HISTORIC LANDMARK COMMISSION
STAFF REPORT

**TRACY AVIARY BIRD HOLDING BUILDINGS
AND AMPHITHEATER**

PLNHLC2011-00648

June 7, 2012

Attachment A
December 1, 2011 HLC Approved Plans

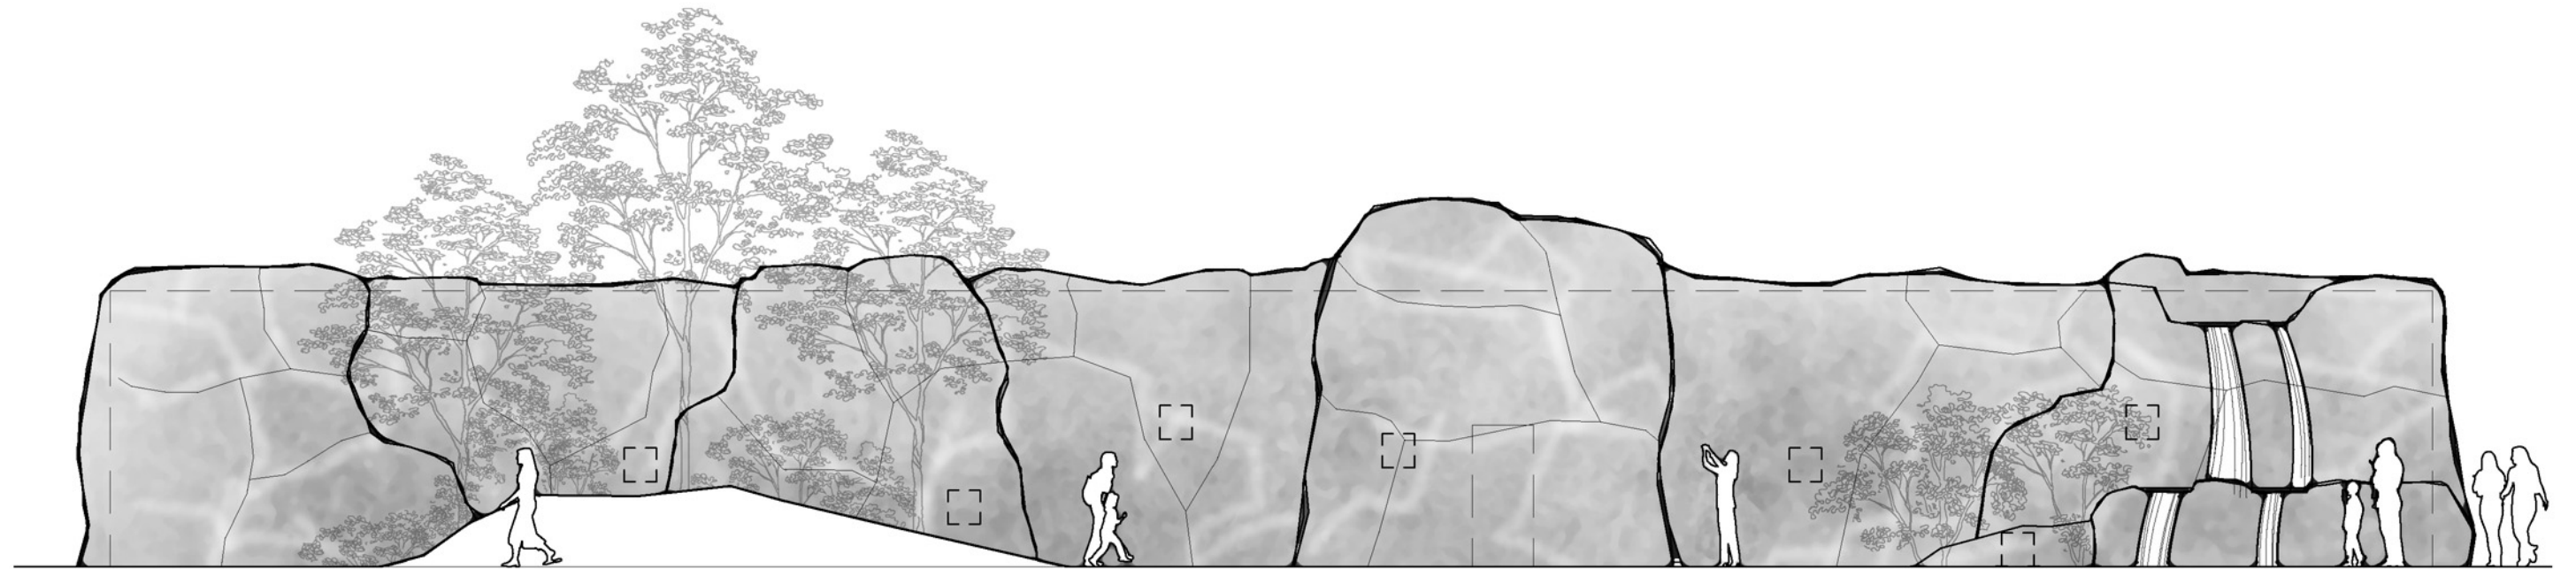
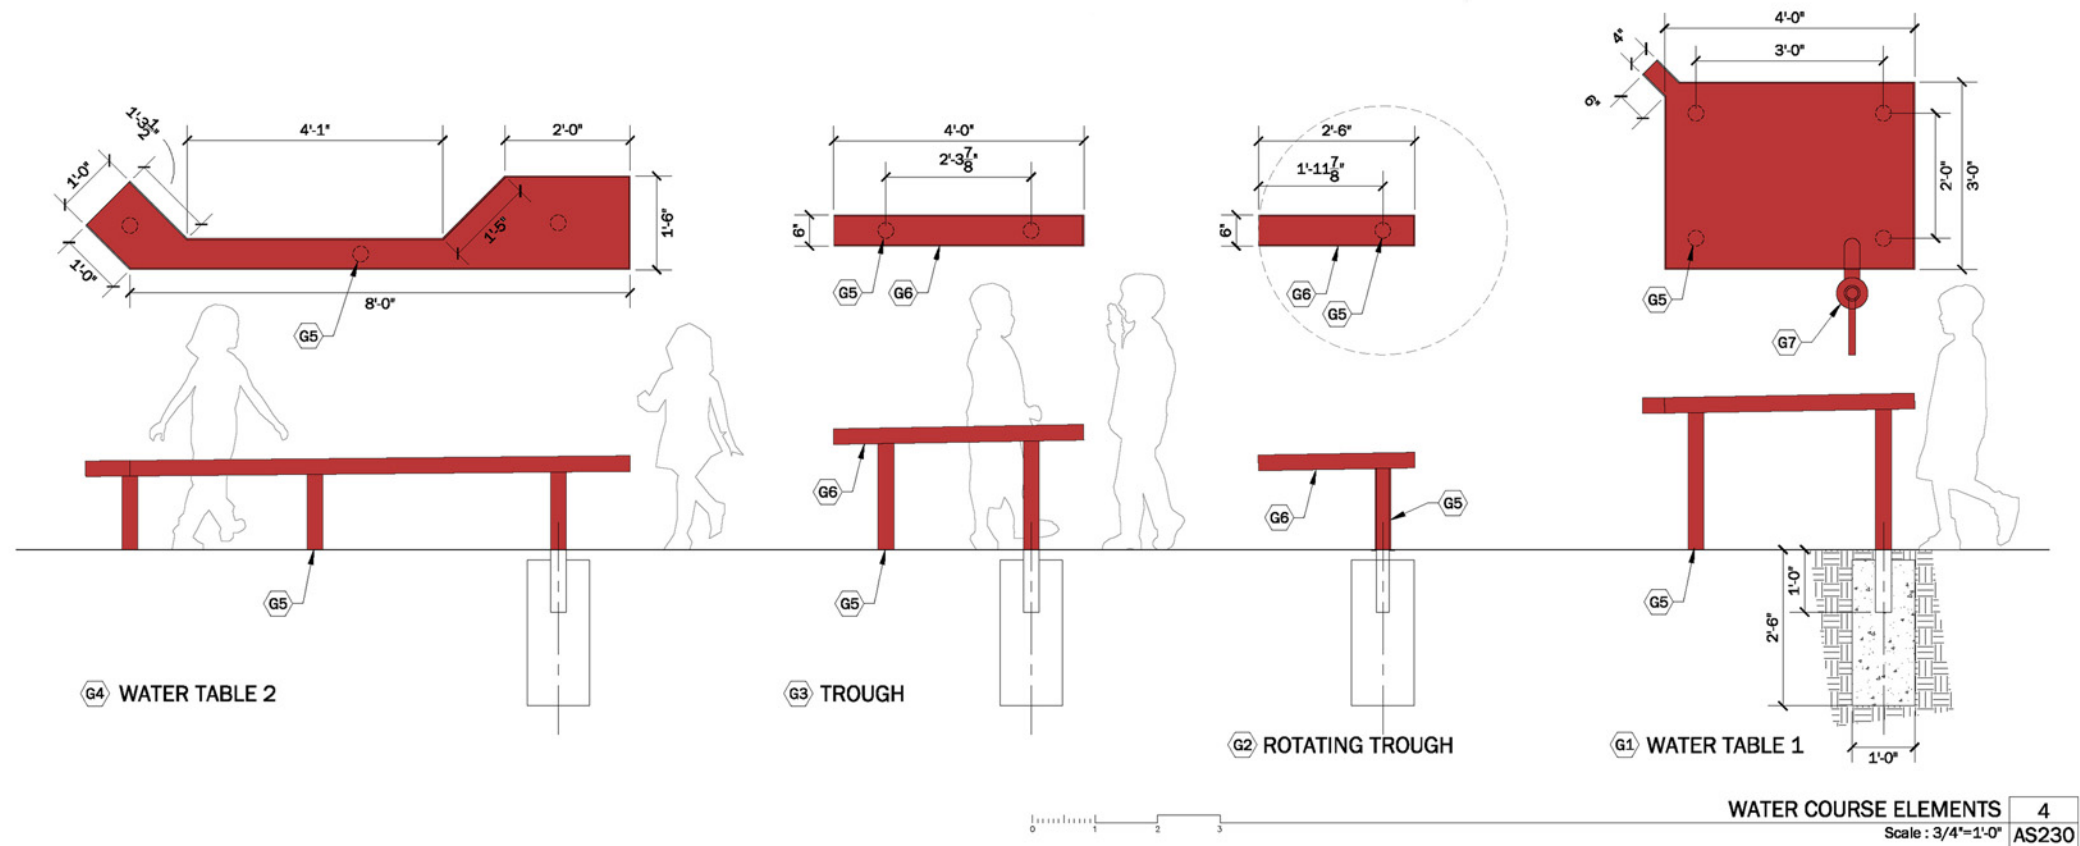
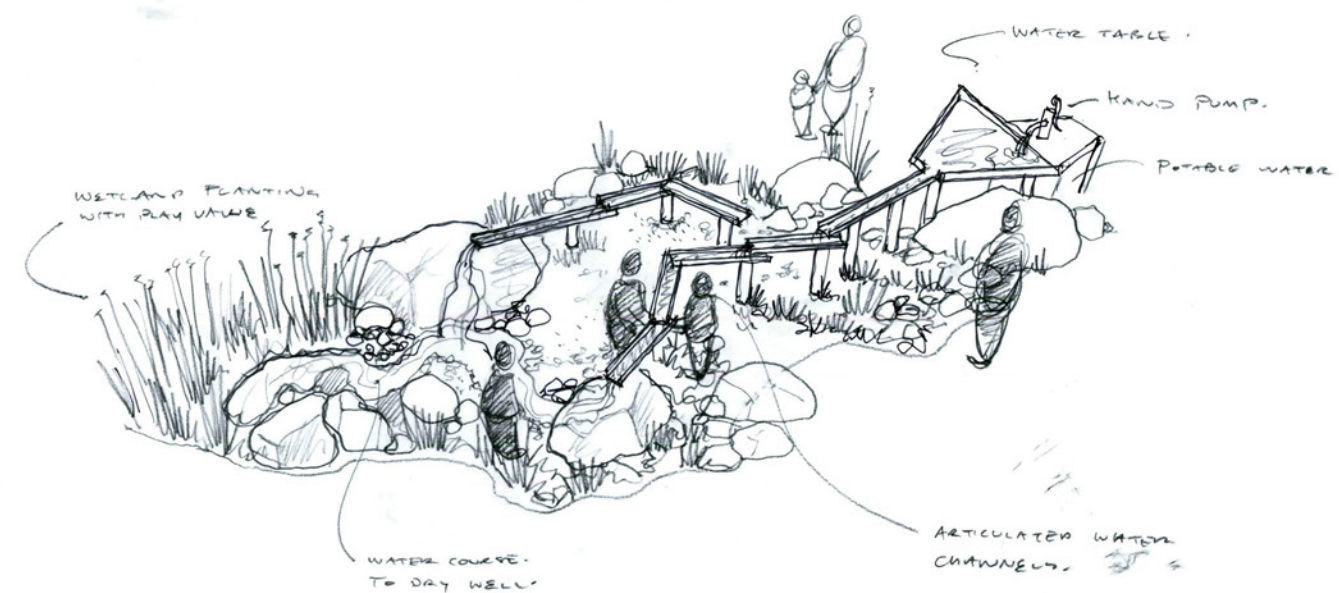
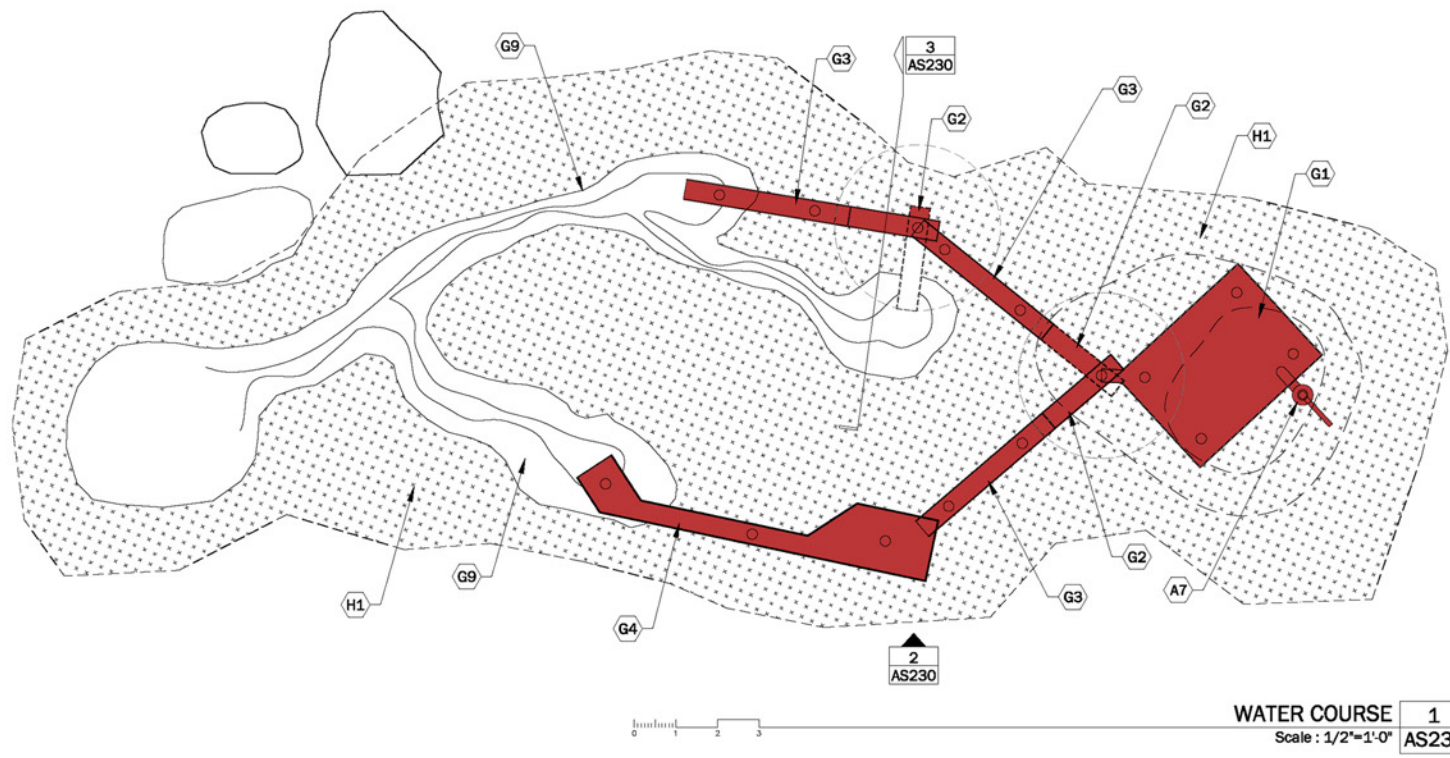
On December 1, 2011, the Historic Landmark Commission reviewed and approved a design for an amphitheater with an attached bird holding building (see approved plans exhibit A). The applicant determined that the approved design would not meet the needed capacity and would be expensive. Therefore, the applicant is requesting that the HLC approve the following modifications:

- Division of single bird holding building into two buildings.
- Construction of a “keeper building” with metal roof and cement based “hardiplank” siding.
- Simplification of design from block building with multiple façade shifts, to utilitarian rectangular buildings with a metal roof and cement based siding or plastic coated chicken wire.

- Elimination of “shotcrete” wall as primary backdrop for the amphitheater stage wall.
- Lining amphitheater stage wall with trees to appear forest like.
- Simplification of amphitheater amenities such as the water feature and playground equipment.

Attachment C
Elevations for Bird Holding Buildings

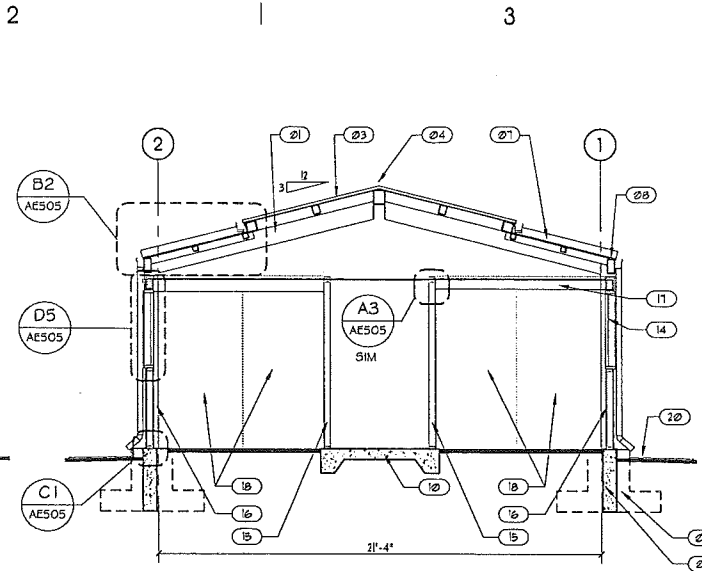
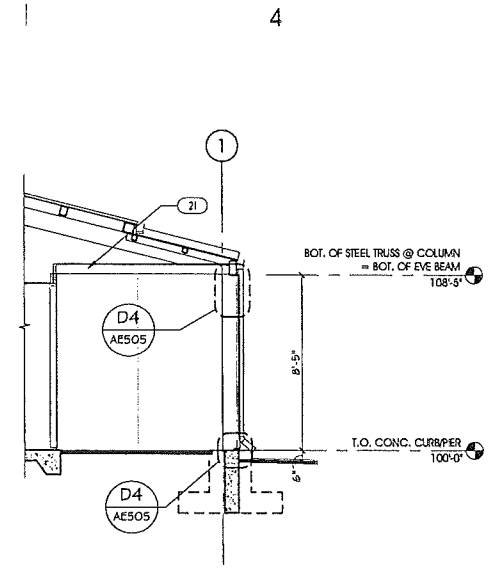
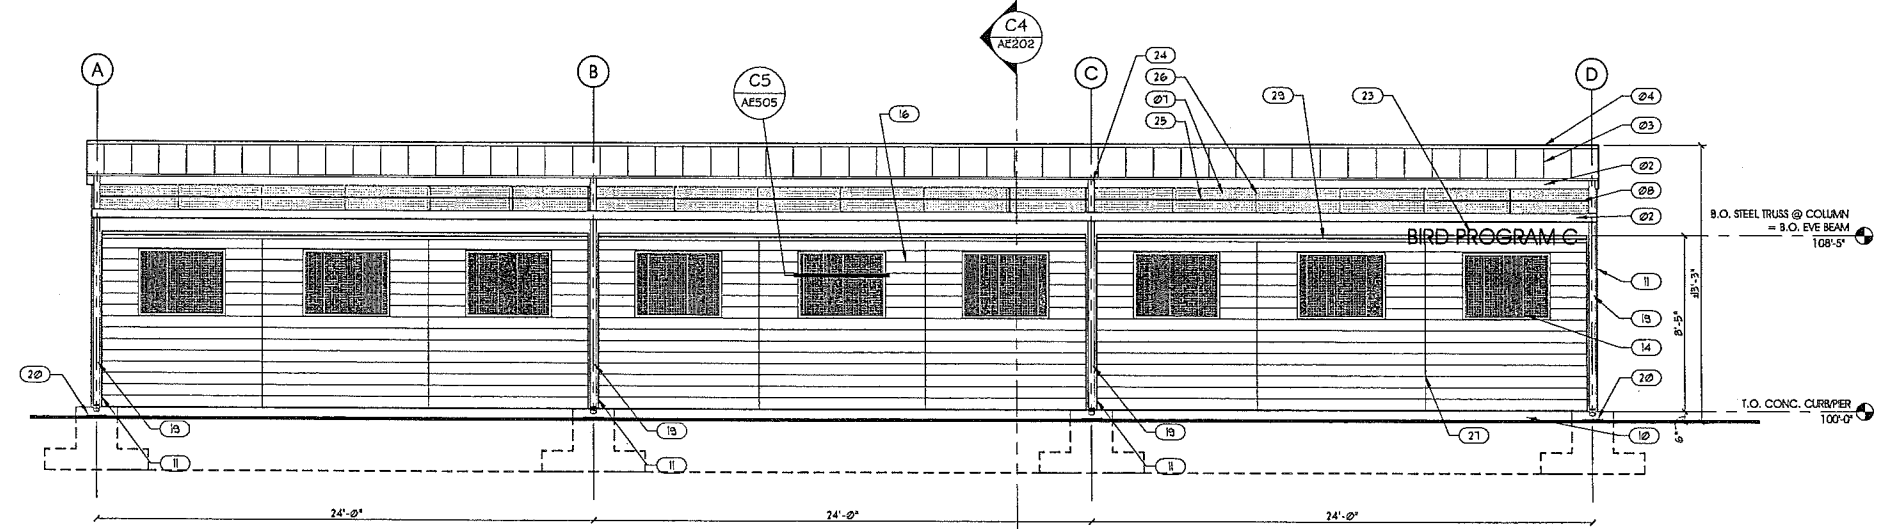
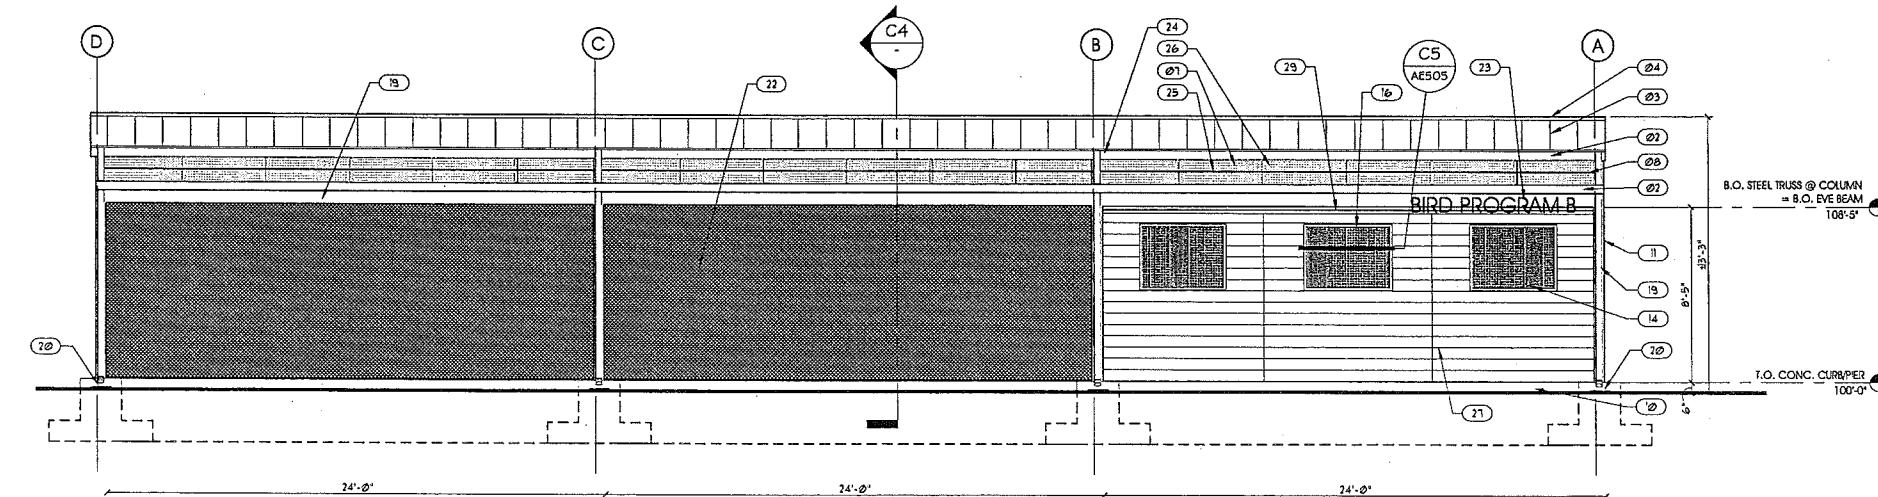
Analysis: The scale and form and function of the proposed holding buildings and keeper building are similar to other display buildings throughout the aviary. Each building has a rectangular footprint and is designed in a linear fashion to maximize the display area for the public. The design is purposely indiscreet and partially transparent so that the birds being held inside can be viewed by the public. The size and scale of the building are mitigated by the low pitch of the roofs, and their lower height (approximately 13 feet above final grade). These design elements will combine to make the structures appear smaller than they actually are. By creating three buildings, the visual mass and scale of the area will be broken into smaller components, and thereby reduces the overall visual mass of the building.

Finding: Staff finds that the 3 proposed buildings are similar to those found throughout the aviary, they are utilitarian buildings designed to cater to the birds, their care takers, and aviary visitors. The unique design of the amphitheater is appropriate due to the needs of the use (bird show support and viewer sight lines). The 13 foot height and the relatively narrow width and length of the building makes it compatible in height, width, proportion, scales, massing and roof shape with other buildings in the Aviary.

Attachment D
Elevations for Keeper Building

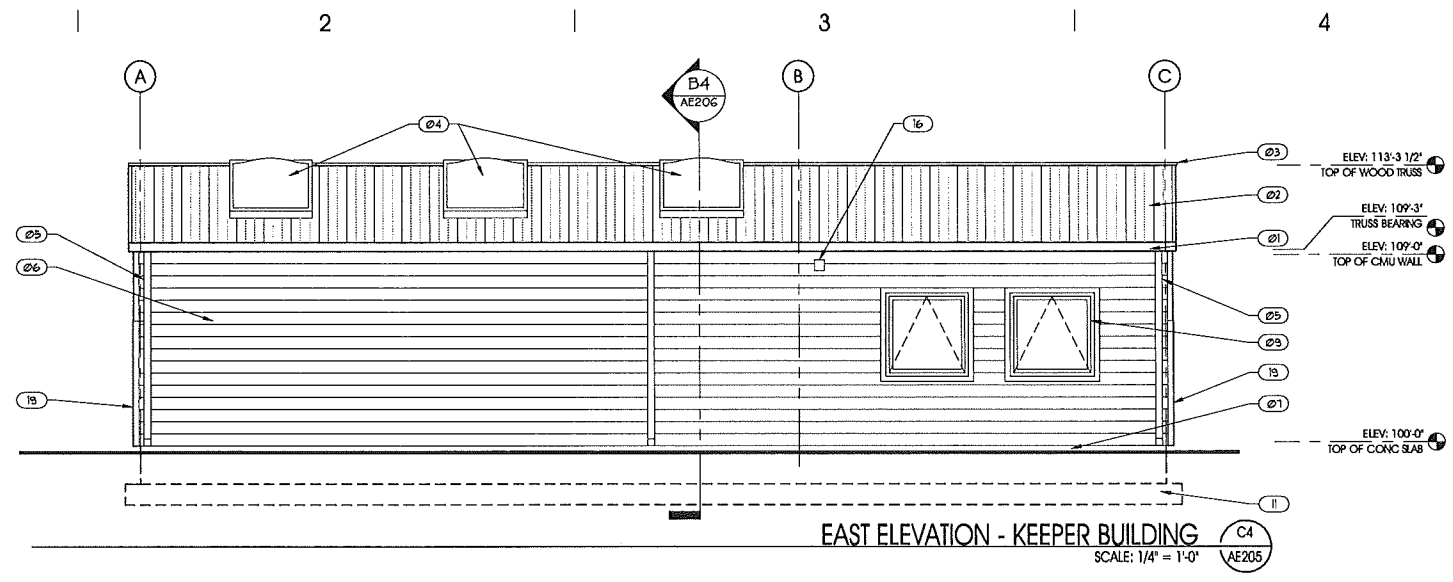
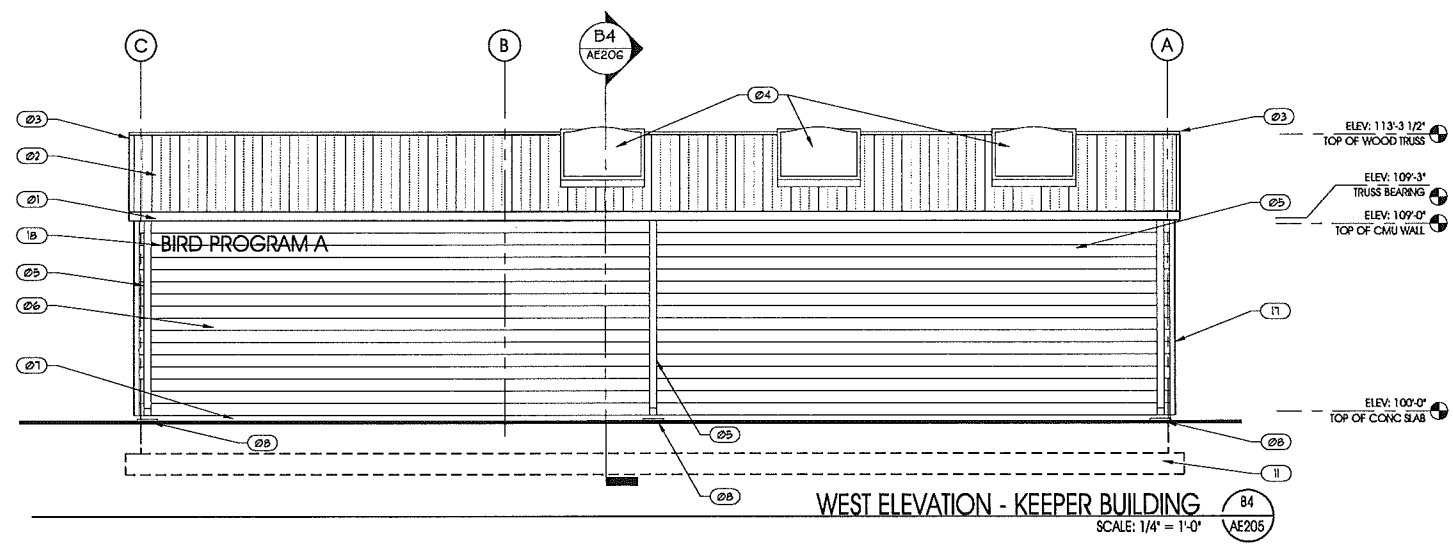
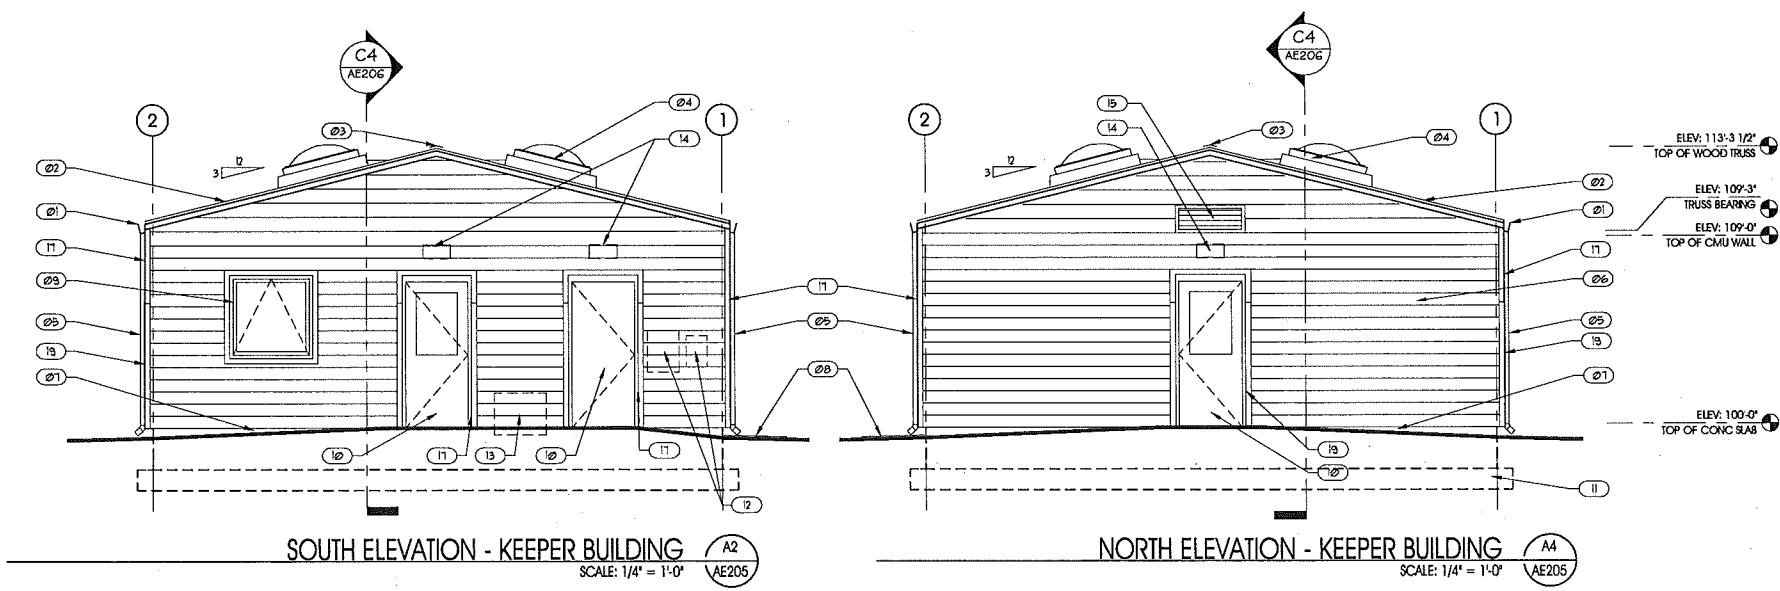
Analysis: The architectural design of the buildings and amphitheater is not one generally associated with historic districts. Nonetheless, it is appropriate for its location and proposed use. The amphitheater is designed to educate and entertain aviary guests and the holding and keeper buildings to house birds for the show and display them to the public. This use is unique to the historic district and as such the design is warranted. The rhythm of solids to voids along the various facades is broken into smaller components by creating three buildings rather than one. The use of the relatively utilitarian architectural detailing, metal roofing, cement based siding and plastic coated chicken wire, is designed to make the building blend into the surrounding landscape and not distract from the bird related theme of the aviary.
